STAFF COMMENTS

NEW BEDFORD HISTORICAL COMMISSION MEETING
February 1, 2016

LOCATION: 38 Bethel Street (Map 53, Lot 103)

APPLICANT: Deborah & Benjamin Baker

Proposed Windows

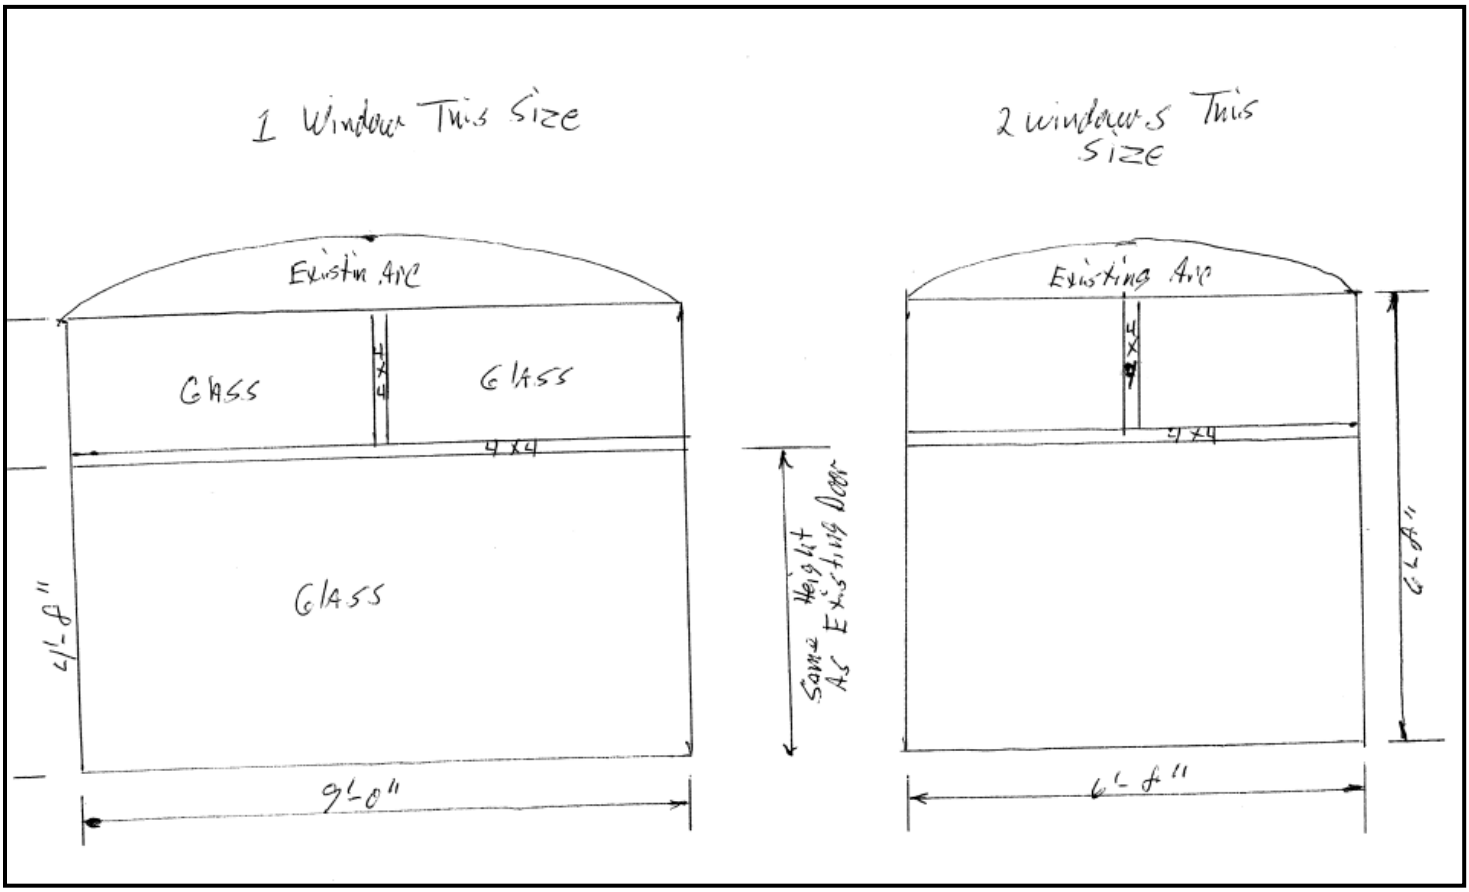
STAFF RECOMMENDATION: The original windows have previously been removed and the proposed replacement, although not replicating the original design, is appropriate and sensitive to the historic character of the building. The new paint color is also appropriate to the building. The custom replacement windows meet the criteria set forth in the District Design Guidelines and should be granted a Certificate of Appropriateness with the following condition: That the four inch divider mouldings be either routed to have a relief profile or have an applied moulding attached to it.
